RE: Quarterly Inspection conducted on July 23, 2019

AFIN 18-00094

Permit Number 0245-S1-R2

Arkansas Department of Environmental Quality Office of Land Resources -Solid Waste Management Class 1 Landfill Inspection

WORKICRITTENDEN COUNTY, ARAR10-1918 (Overfill Removal)/OVERFILL CERTIFICATION MAP. dwg. 7/30/2019 11:22:13 AM, DWG TO PDF.pc3

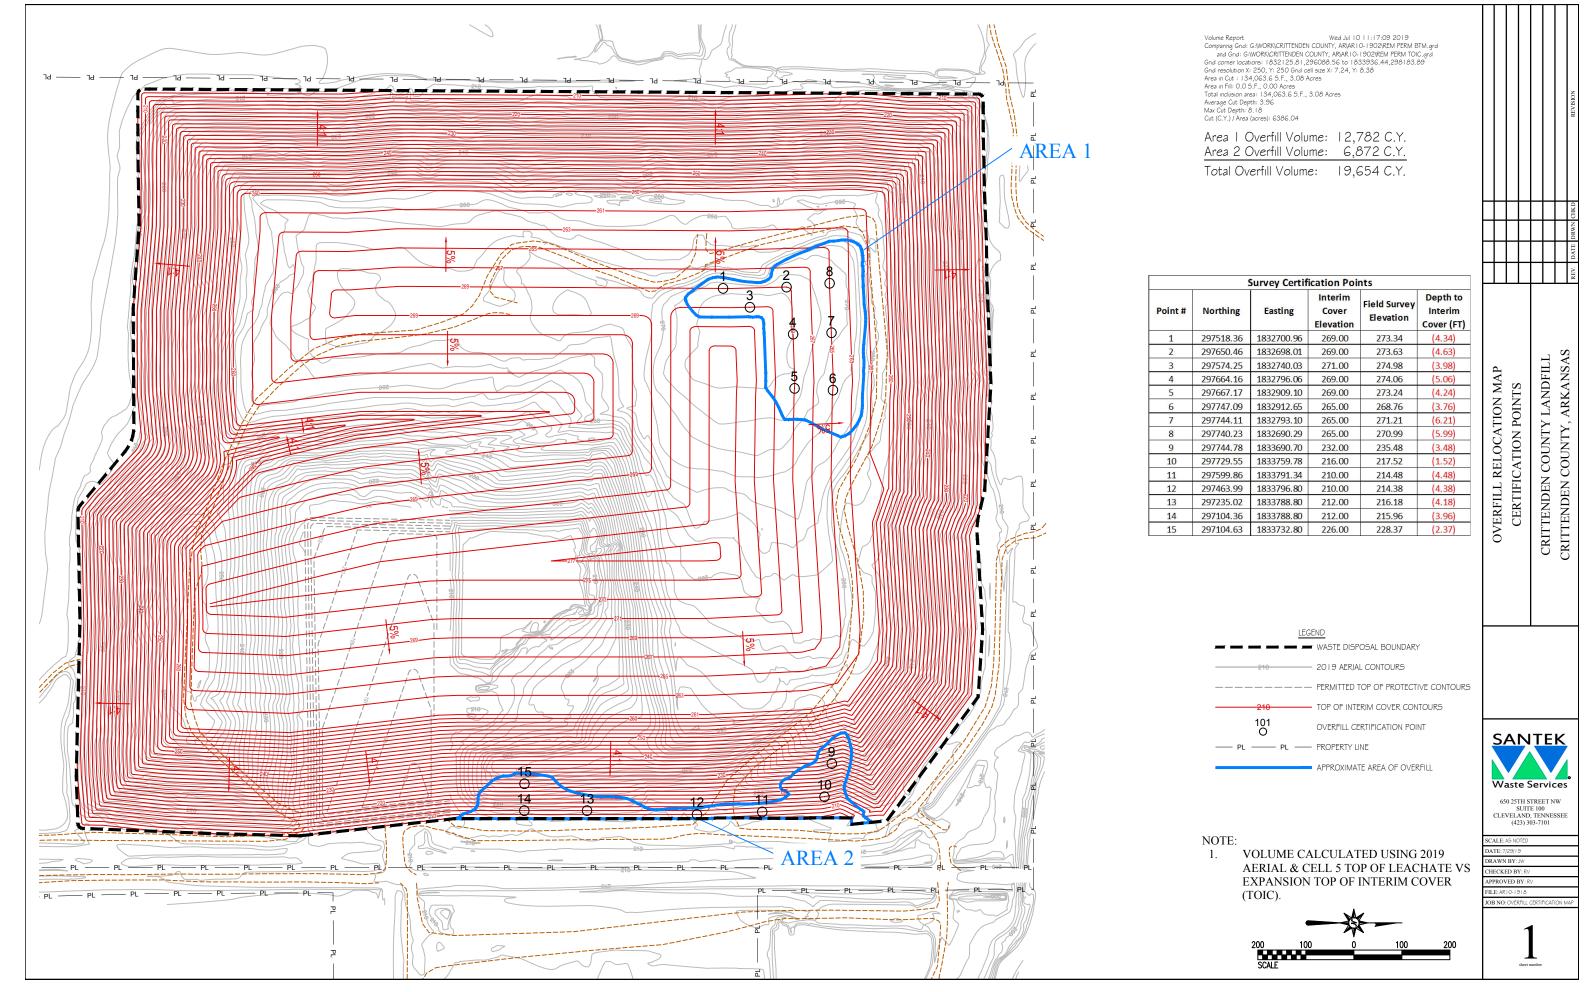
In accordance with ADEQ Regulation 22.309(c), Santek is submitting this Overfill Removal Plan to relocate the overfill within the permitted grades to achieve compliance in the two areas. An Overfill Certification Map has been attached showing the limits of the two overfill areas. Also included on the map is a survey certification points table. Once the overfill is removed, the certification points will be resurveyed in order to show compliance.
